ADDENDUM No. 3
FOR
LINK – Multi-Use Development
BID PACKAGE – All Trades

Date of Issue: April 24, 2023

LINK – Addendum #3 Narrative

4/21/23

4 STAIR 2 - THIRD FLOOR PLAN
1/4" = 1'-0" REFERENCE: 1/A504A

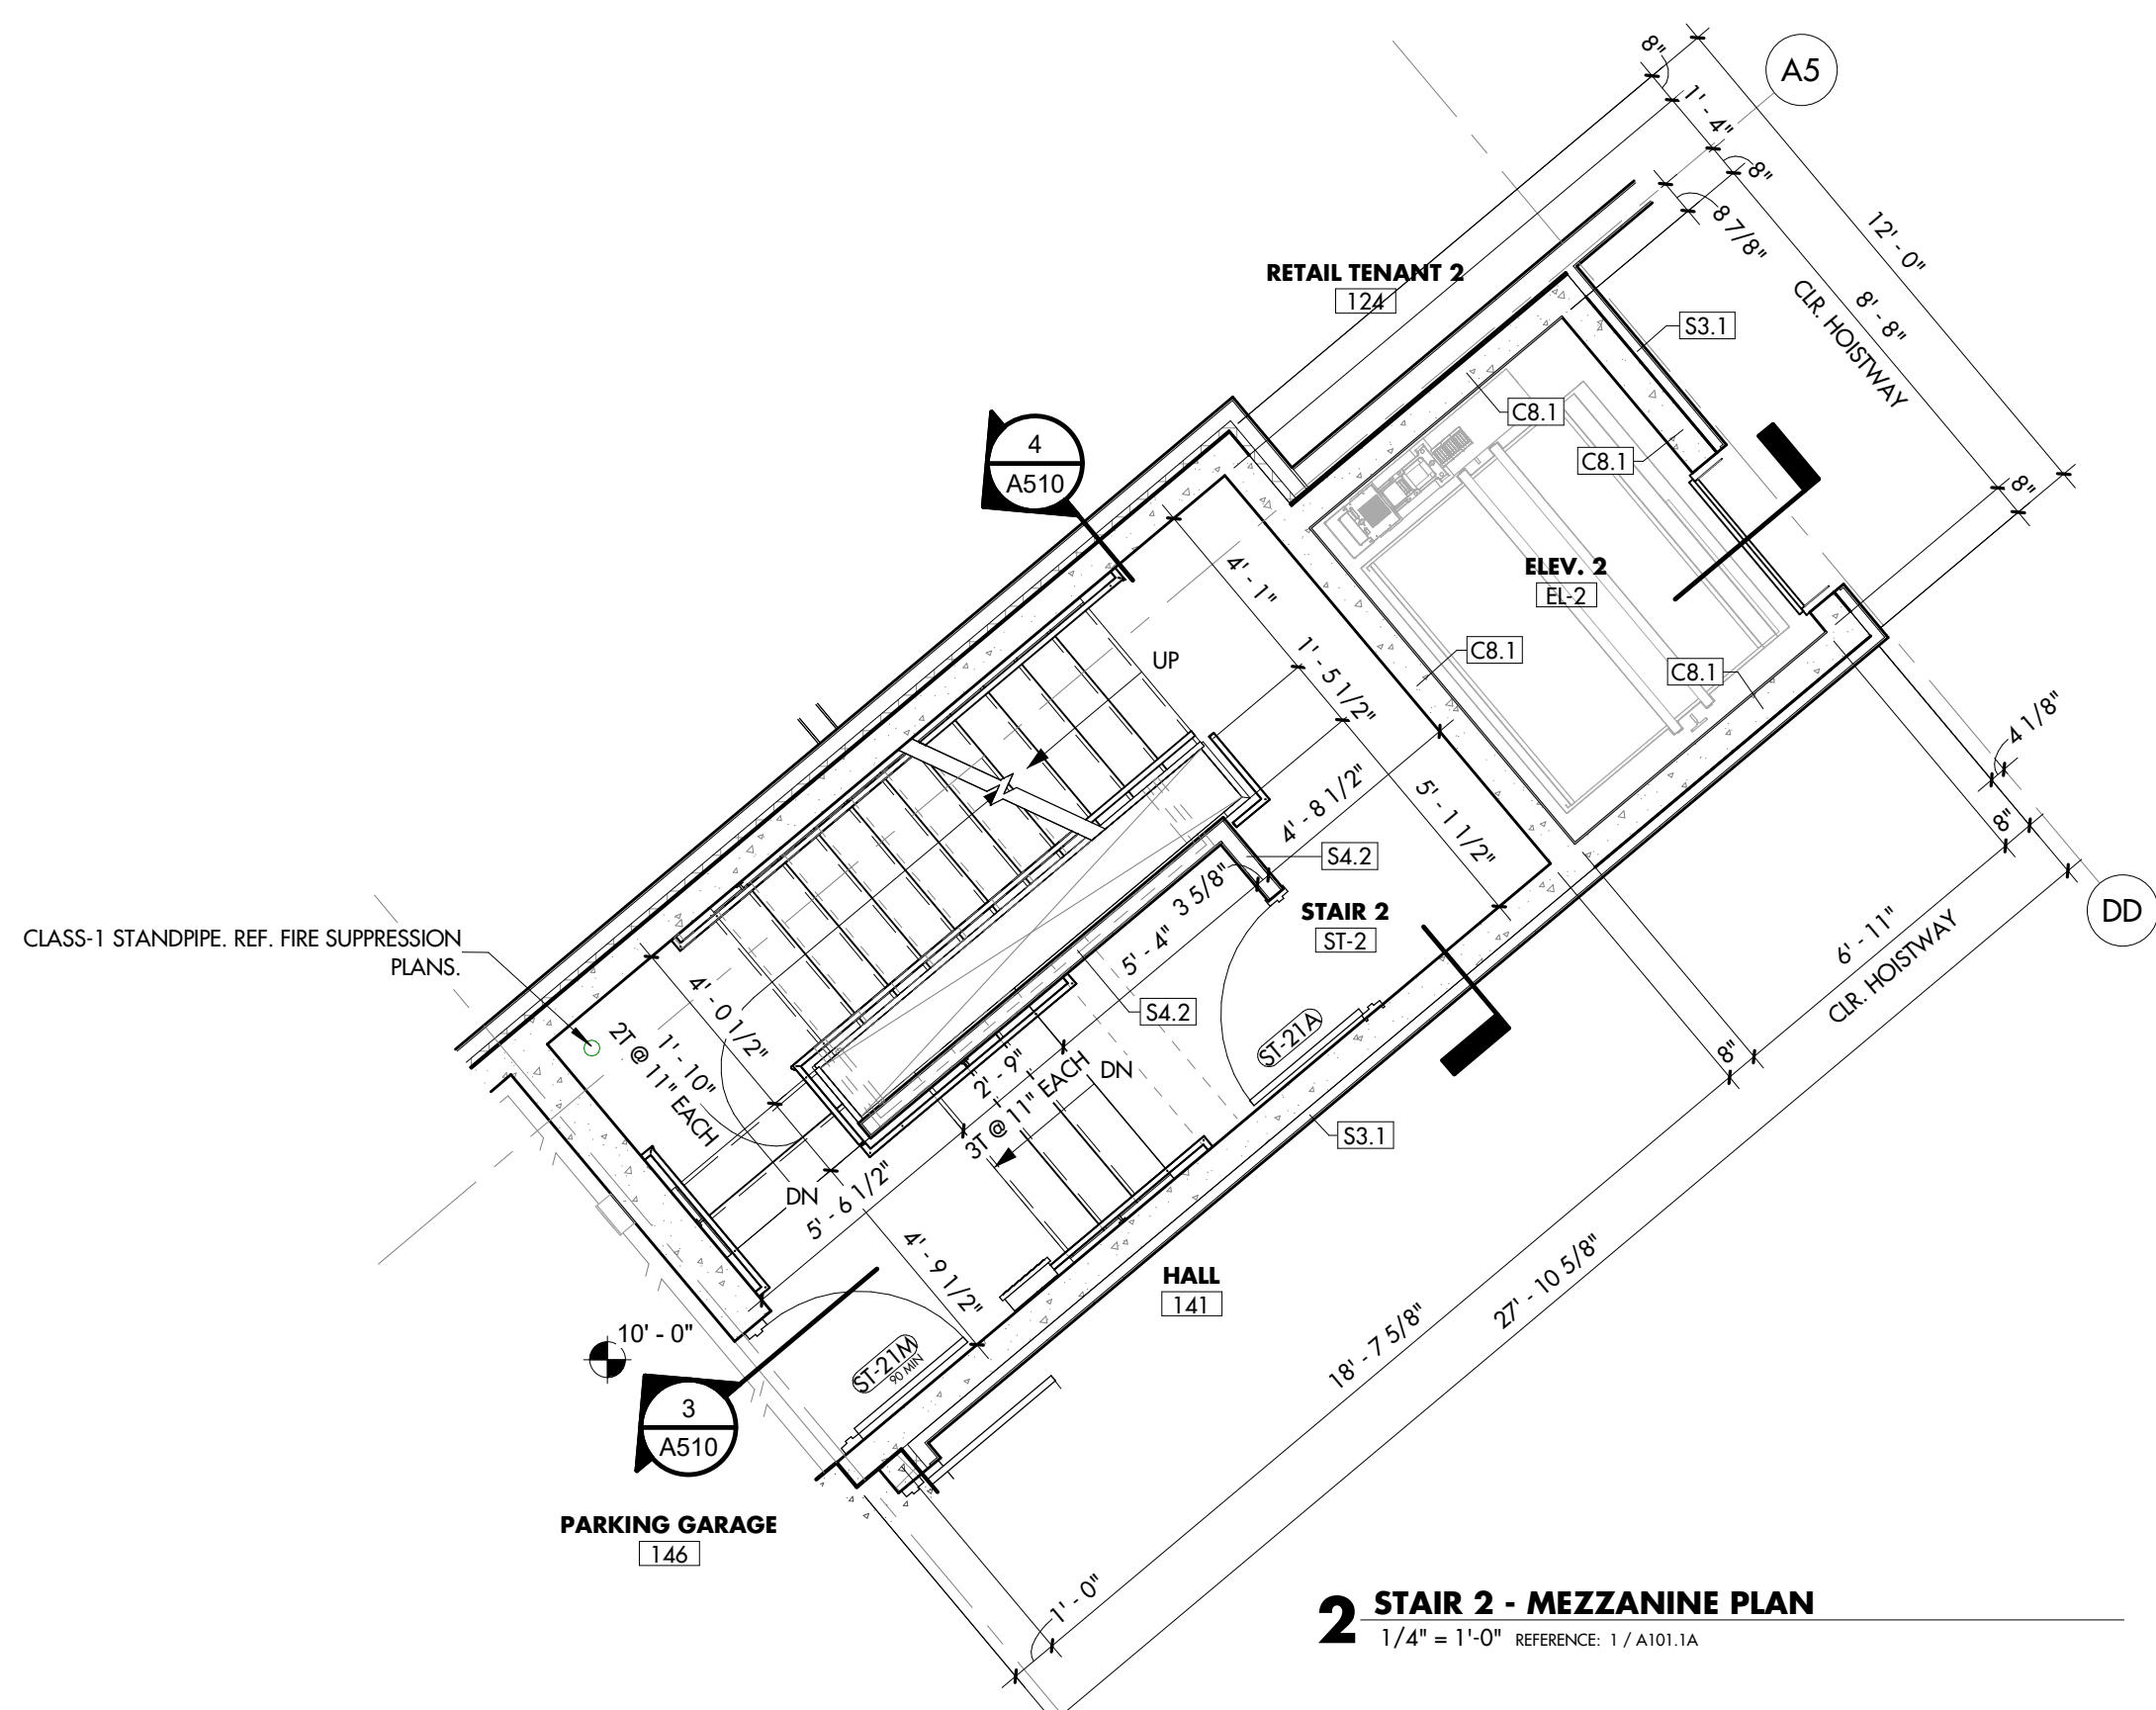
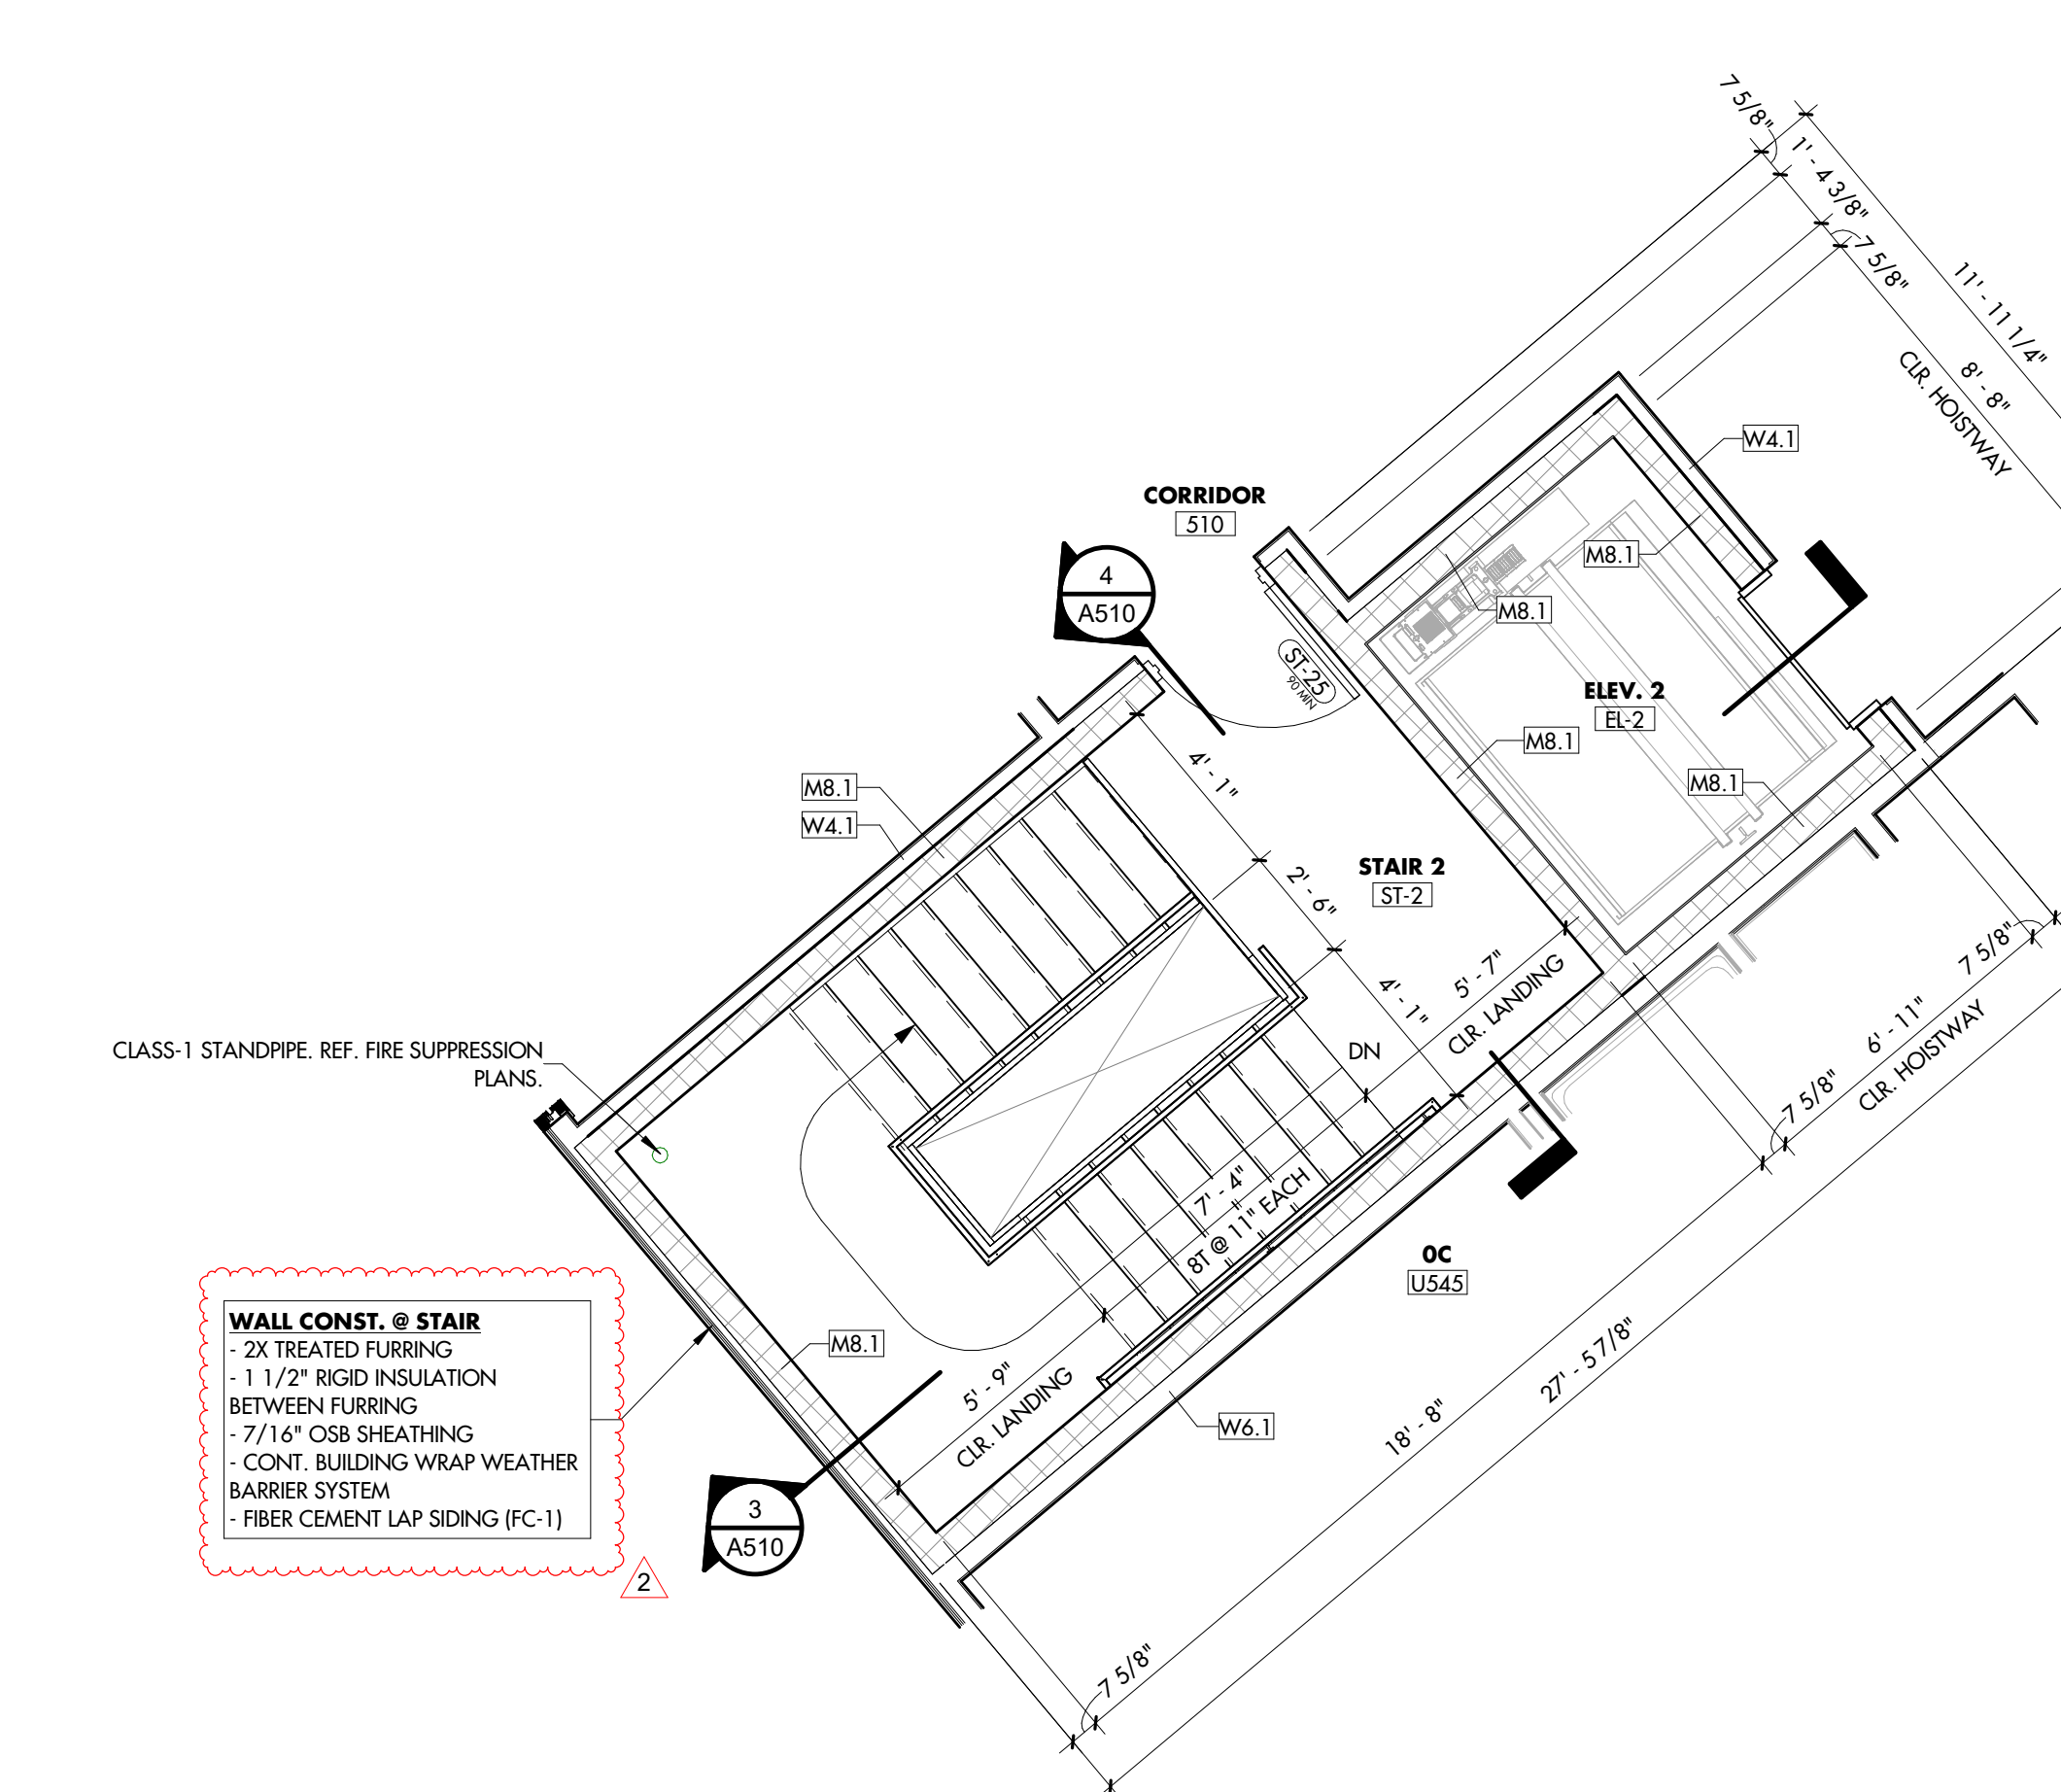
- A504
 - Clarified exterior wall construction at stair.
- A601
 - Revised door finishes.
- A602
 - Revised door finishes.
 - Revised pre-hung unit door heights.
